TECHNICAL BULLETIN

[Issue No.] T17-0003-A

[Title] Product discontinuation of AnS series temperature control modules

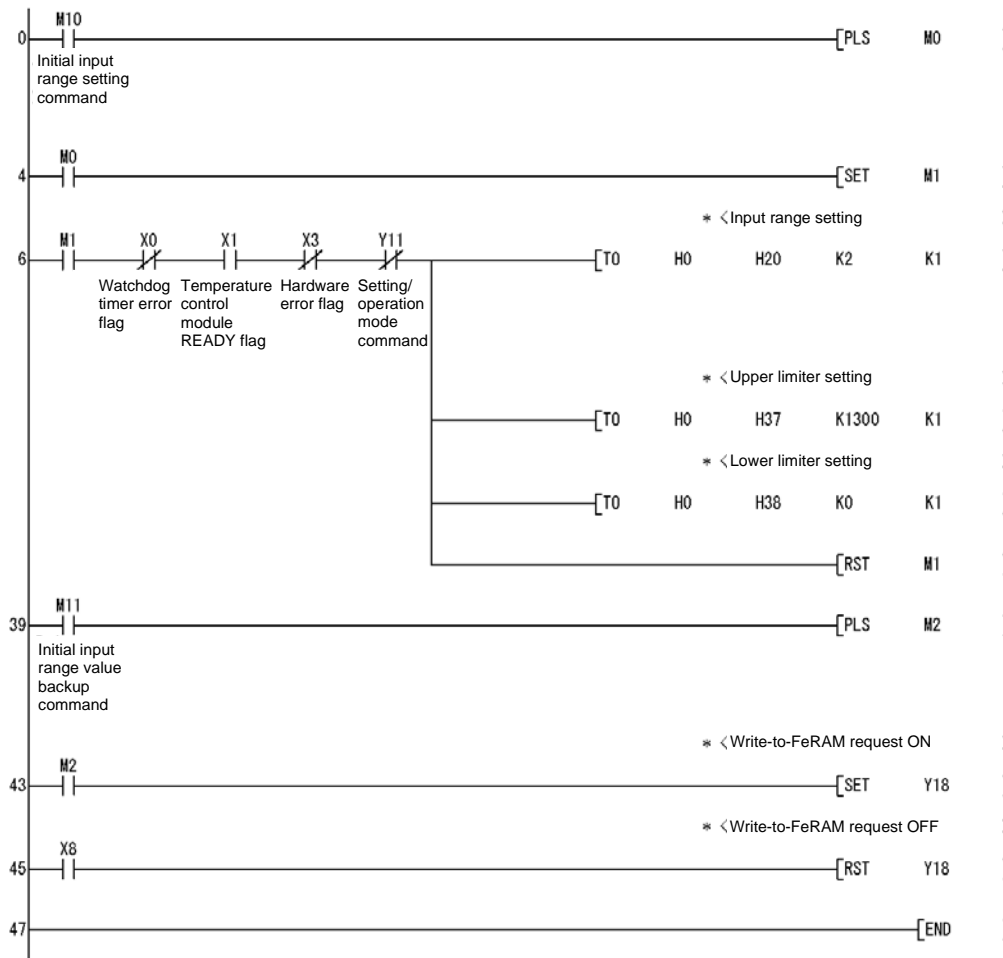
The following is a program for backing up the input range setting. (An example in the case where a temperature control module is installed to I/O slot 0 of the main base unit)

Note that the following settings must also be made in accordance with the input range setting.

- Upper setting limiter (buffer memory address: 37H, 57H, 77H, 97H/37H, 57H^{*1})
- Lower setting limiter (buffer memory address: 38H, 58H, 78H, 98H/38H, 58H^{*2})

*1 The addresses, 37H, 57H, 77H, 97H are used for Standard control, and 37H, 57H for Heating-cooling control.

*2 The addresses, 38H, 58H, 78H, 98H are used for Standard control, and 38H, 58H for Heating-cooling control.
